SANTA ANA RIVER DISCHARGERS ASSOCIATION (SARDA)

Re: Comment Letter - Toxicity Provisions

On behalf of the Santa Ana River Dischargers Association (SARDA), we submit this comment letter regarding the Proposed Establishment of New Toxicity Provisions in the Water Quality Control Plan for Inland Surface Waters, Enclosed Bays, and Estuaries of California.

Fig. 2: Probability of False Failure as a Function of Control Variability for C. dubia Reproduction

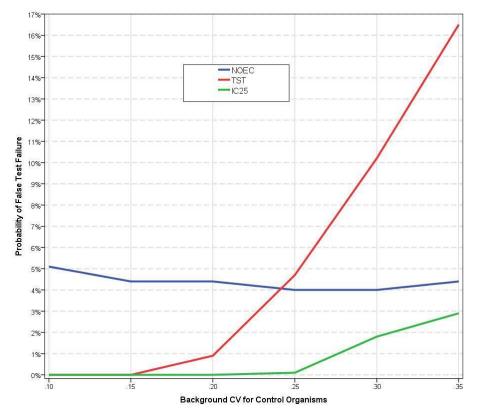
4.4 Based on the results from a computer simulation study described in written comments previously submitted to the State Board, the accuracy of the TST method degrades rapidly when the inter-replicate coefficient-of-variation (CV) is greater 20%.⁴⁶ The table and chart below provide a visual summary of the simulation study data that was previously presented in Risk Sciences' 2012 comment letter.

It is when the CV is greater than 25% that the TST procedure is most likely to lead to false conclusions regarding potential toxicity in the effluent sample. It should be noted that the computer simulation studies, performed by TetraTech in order to develop the TST procedure, used synthetic datasets with an assumed Coefficient of Variation of less than 20%. Data from the Test Drive Study reveals that the real-world CV is greater than the assumed value nearly 40% of the time (see Fig. 3).

Fig. 3: CV for C. dubia Reproduction in Control Group Data from the TST Test Drive Study

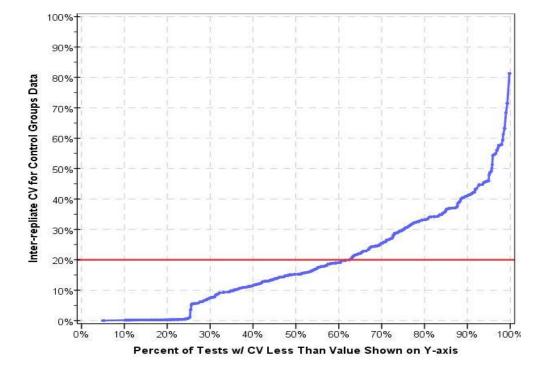
Review of control performance data from the Ceriodaphnia dubia reproduction tests analyzed during the TST Test Drive Study shows that the inter-replicate coefficient-of-variation (CV) exceeded 25% about one-third of the time. In one-fourth of the tests the CV was greater than 30% and 10% of the time the CV was greater than 40% (see Fig. 3, below).
